Stream and Wetland Mitigation Plan

UT to Town Creek Restoration Project - Option A

Re: NCIRT Review and USACE Approval of the UT to Town Creek Stream and Wetland Mitigation Plan; SAW-2013-01280; NCEEP Project # 94648

SUBJECT: UT to Town Creek - NCIRT Comments During 30-day Mitigation Plan Review

Figure 6. Proposed Conditions Map
 UT to Town Creek Restoration Site - Option A
 Stanly County, NC

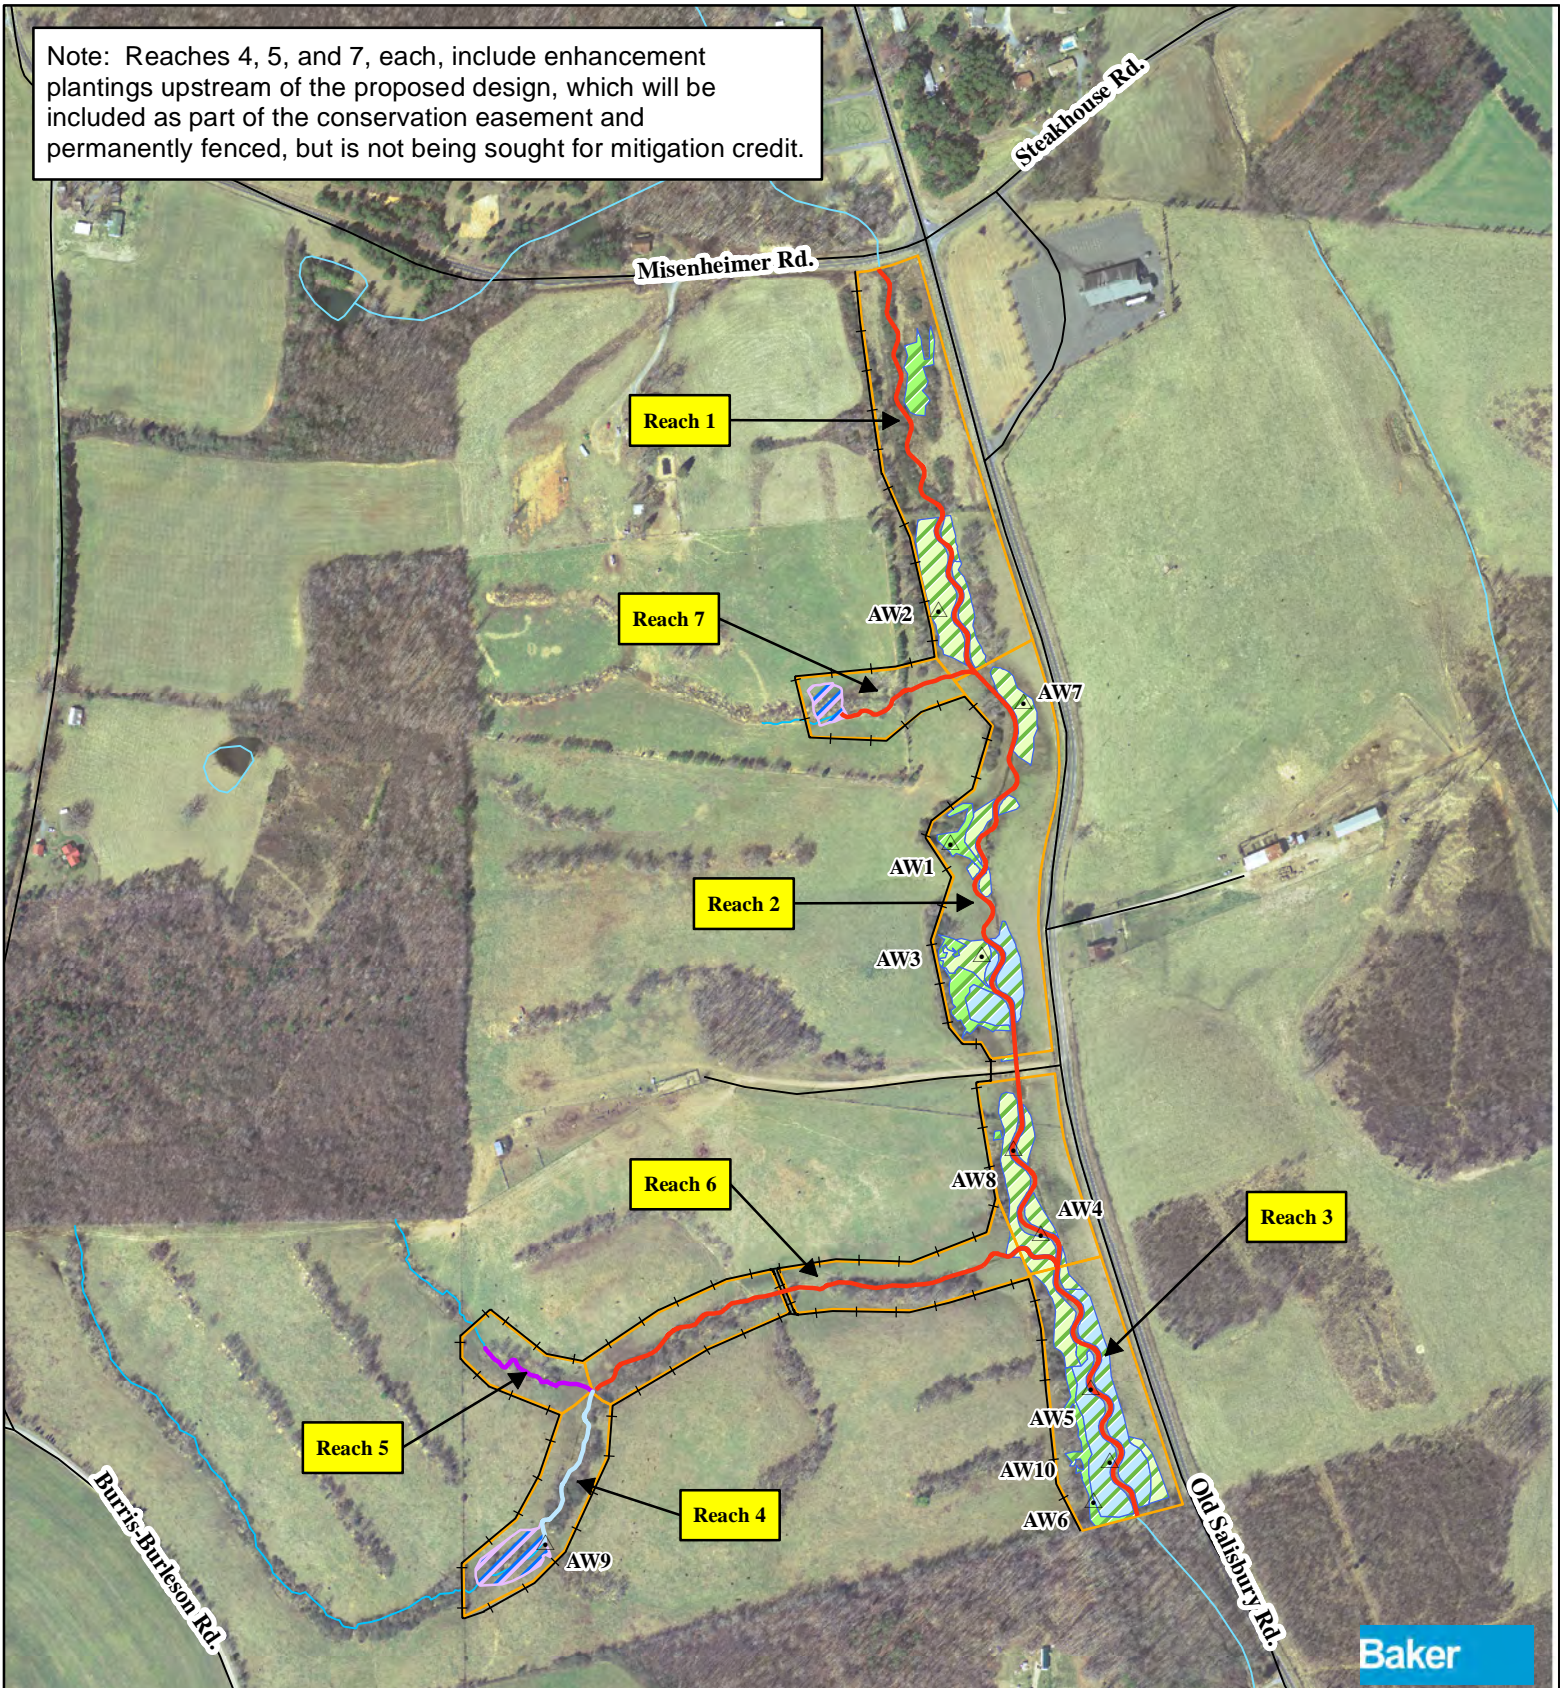
1. Notate on Figure 6 that area upstream of Reach 4, 5, and 7 is non-credited preservation as noted on pg 7-5 in Notes section.
2. Wetland indicator status listed on pages 7-31 and 7-32 should be updated to current National Wetland Plant List for the EMP region for 2014 which does not have “+” and “-” designations. Please correct the following: *Liriodendron tulipifera* to FACU, *Quercus phellos* to FAC, *Alnus serrulata* to OBL, *Sambucus Canadensis* to *Sambucus nigra* FAC, *Nyssa sylvatica* to FAC, *Hibiscus moscheutos* to FACW, *Elymus virginicus* to FACW, *Tripsacum dactyloides* to FACW, *Coreopsis lanceolata* to FACU, *Dichanthelium clandestinum* to FAC. http://rsgisias.crrel.usace.army.mil/nwpl_static/viewer.html#

1. Notate on Figure 6 that area upstream of Reach 4, 5, and 7 is non-credited preservation as noted on pg 7-5 in Notes section.

Response: As requested, a notation has been added to Figure 6 to stipulate that the areas upstream of the proposed design on Reaches 4, 5, and 7, will include enhancement plantings and be included as part of the conservation easement and permanently fenced, but are not being sought for mitigation credit.

Note: Reaches 4, 5, and 7, each, include enhancement plantings upstream of the proposed design, which will be included as part of the conservation easement and permanently fenced, but is not being sought for mitigation credit.

Figure 7. Proposed Monitoring Device Locations
 UT to Town Creek Restoration Site - Option A
 Stanly County, NC

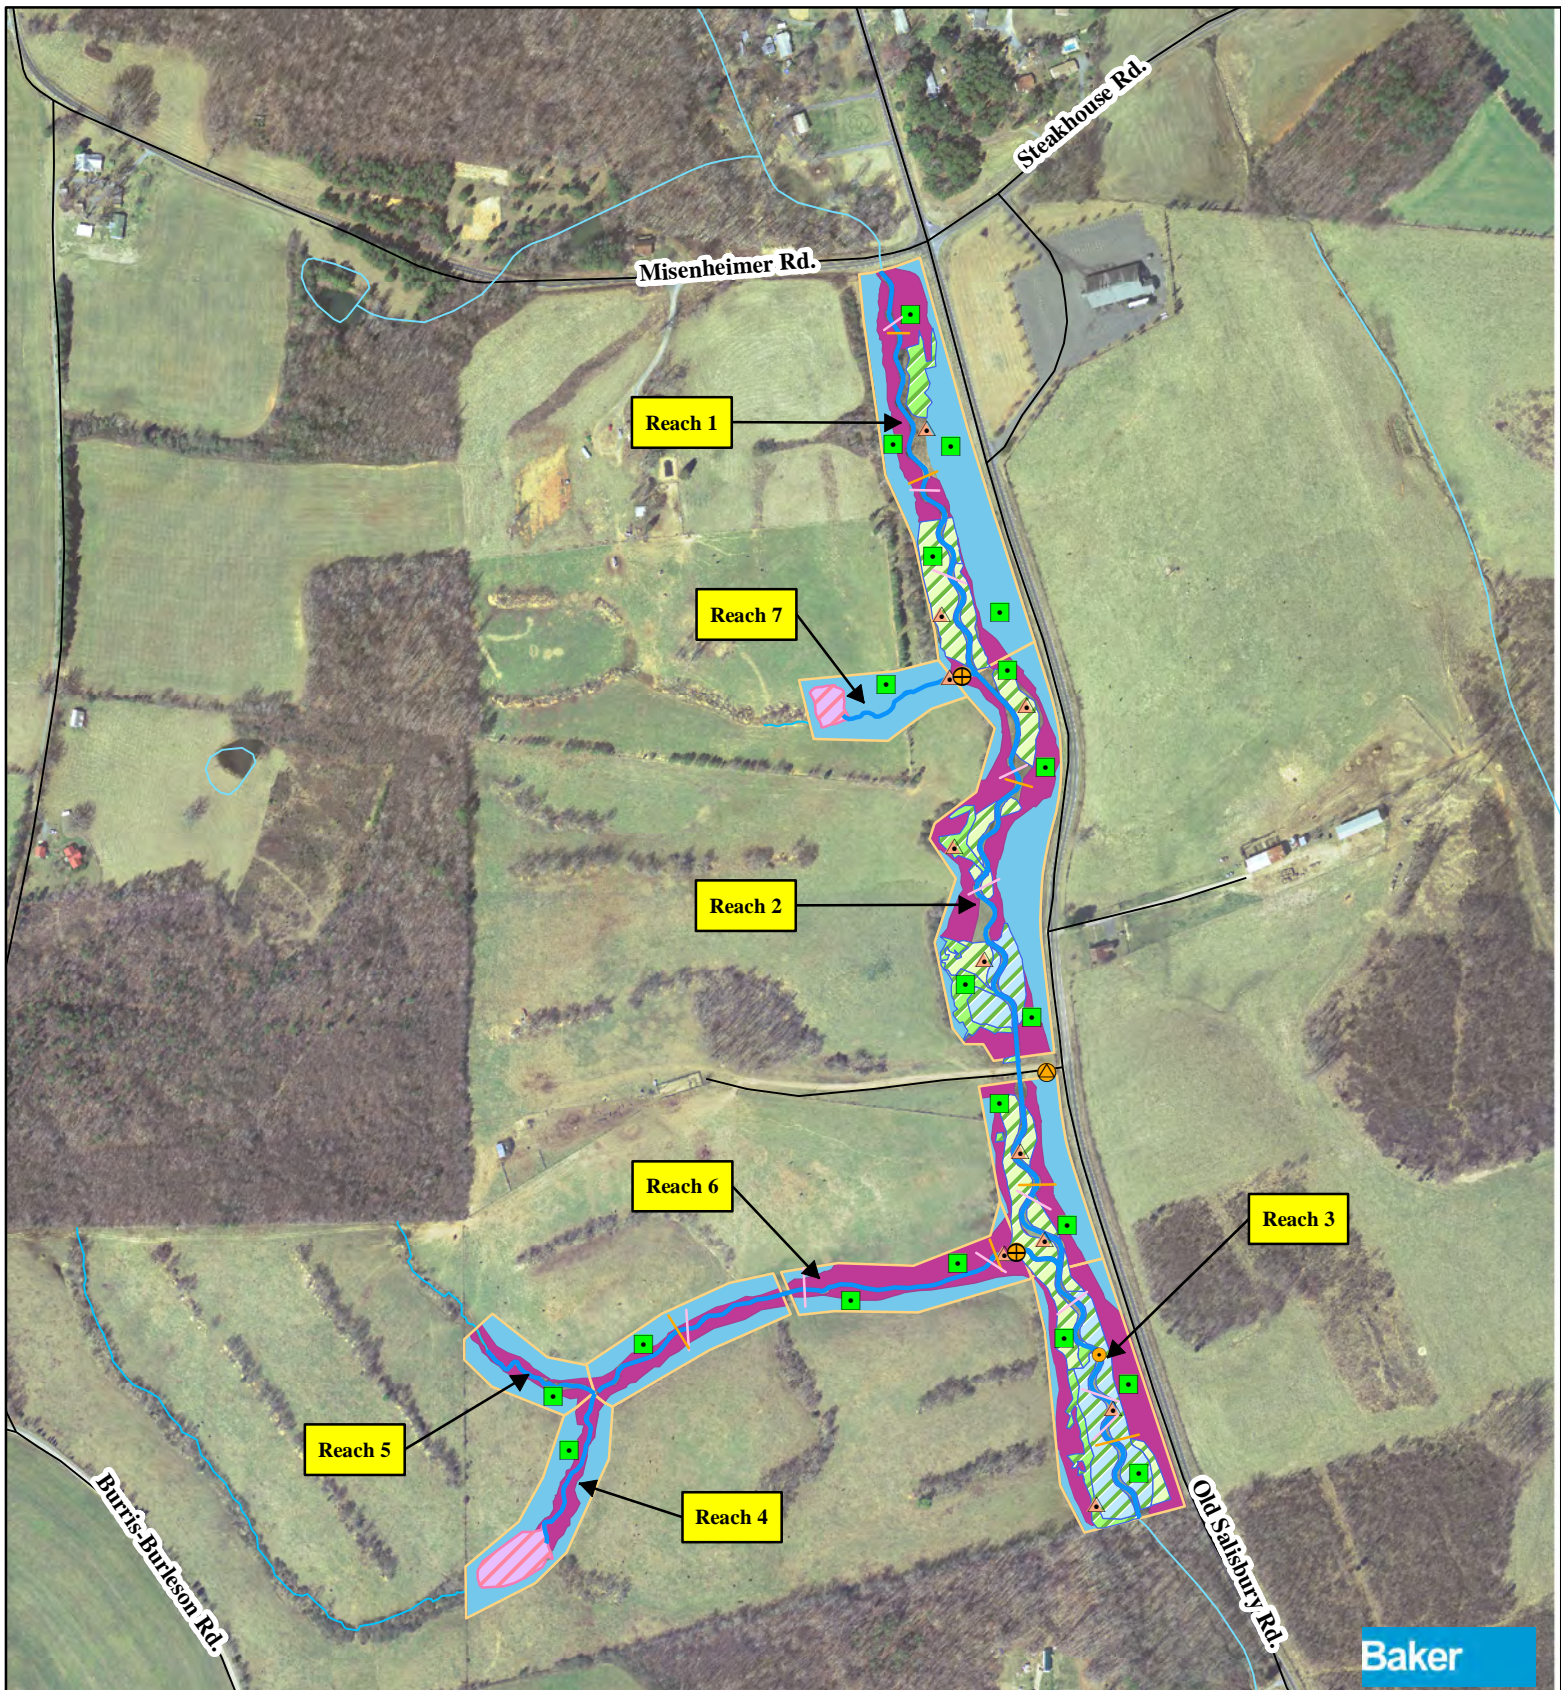
4. Recommend a figure or map showing the areas where upland, riparian, and forested wetland plantings will occur. Vegetation plots established for monitoring should adequately cover each of these different vegetation communities.

4. A vegetation monitoring plot should be added (or moved into) the enhancement area.
5. DWR recommends using burlap, or more natural light weight core fiber material that would degrade quicker rather than geo-tech fabric for soil lifts and grade control/cross vanes etc.

4. Recommend a figure or map showing the areas where upland, riparian, and forested wetland plantings will occur. Vegetation plots established for monitoring should adequately cover each of these different vegetation communities.

Response: *Riparian, upland, wetland planting areas have been added to Figure 7 – Proposed Monitoring Device Locations and are also depicted in sheets 24 – 27 of the plan set. Vegetation plot locations have been strategically placed to include an adequate mix of the vegetative communities. See Figure 7 for reference.*

Response: *A vegetation monitoring plot has been relocated to the wetland enhancement area of Wetland 3 as suggested. See Figure 7.*
